## REMARKS

## **Amendments to the Drawings:**

FIG. 3

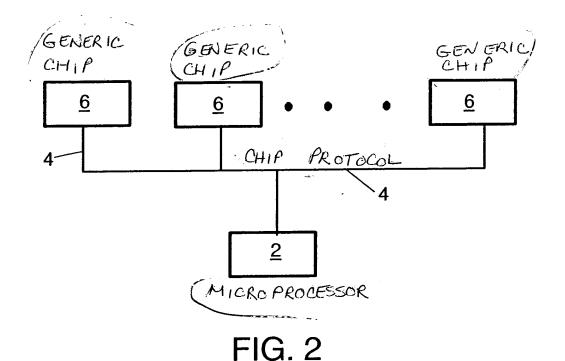
In paragraph 1 of the office action, the examiner objects to drawings Fig. 1 for containing misspelling of Successful; Fig. 2 and Fig. 3 for not including textual labels. The applicant has amended the drawings accordingly. The applicant respectfully submits that the drawings as amended put the application in condition for allowance, which allowance is respectfully requested.

The attached sheets of drawings include changes to FIGs. 1-4. In FIG. 1 spelling of successful has been corrected. In FIG. 2 textual labels have been added. In FIG. 3 textual labels have been added. I FIG. 4, textual labels have been added and the drawing allegiance of reference number 6 has been corrected.
